LIMITING CONDITIONS FOR OPERATION AND SURVEILLANCE REQUIREMENTS

Docket Number 50-346
License Number NPF-3
Serial Number 2470
Enclosure 2

Relocate the requirements of TS 3/4.1.2.8 and 3/4.1.2.9 to the TRM.

Figure 3.1-1 Boric Acid Addition System
Minimum Required Volume as
a Function of Boric Acid
Concentration Required in
Modes 1-4

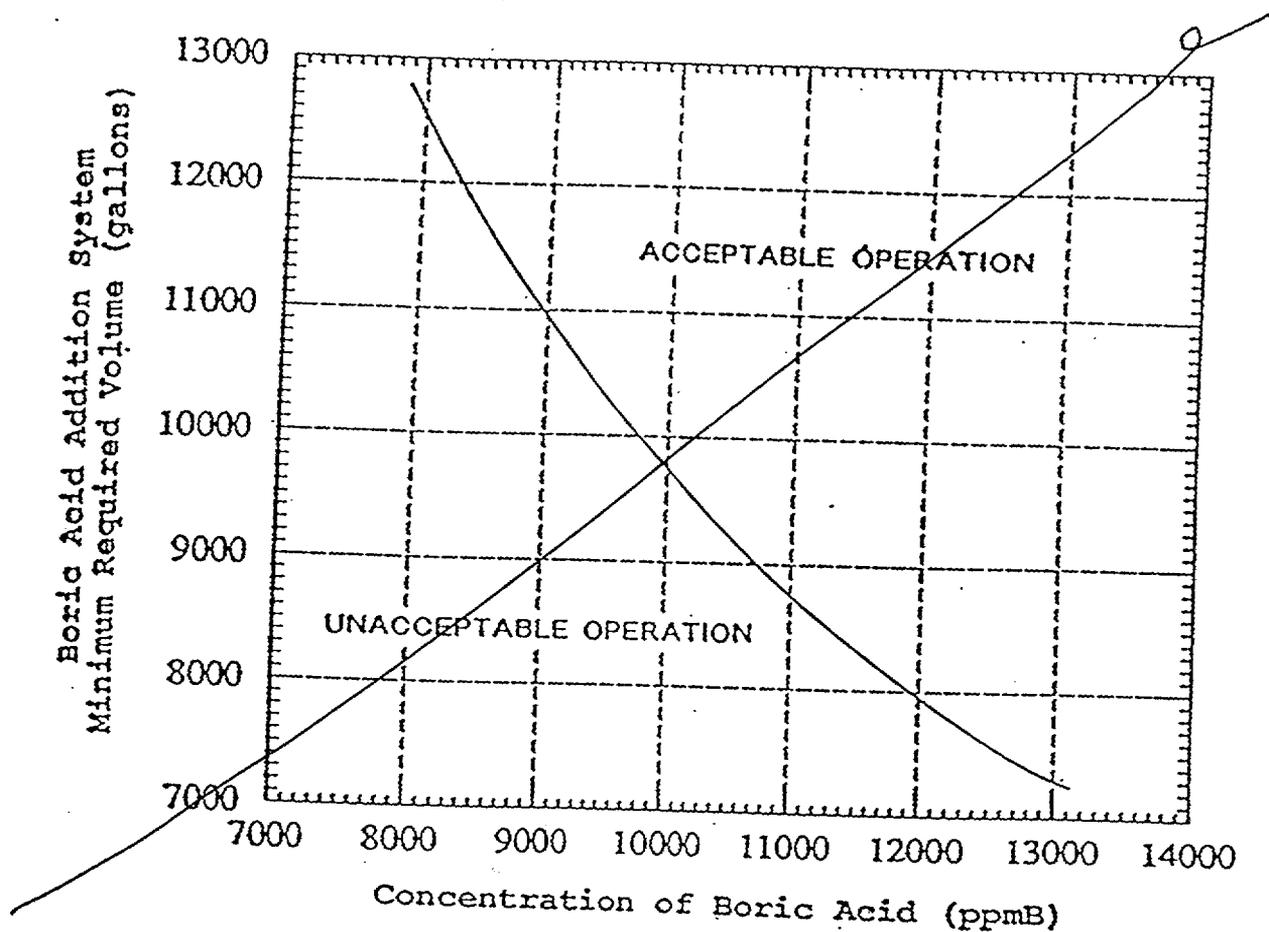
DELETED
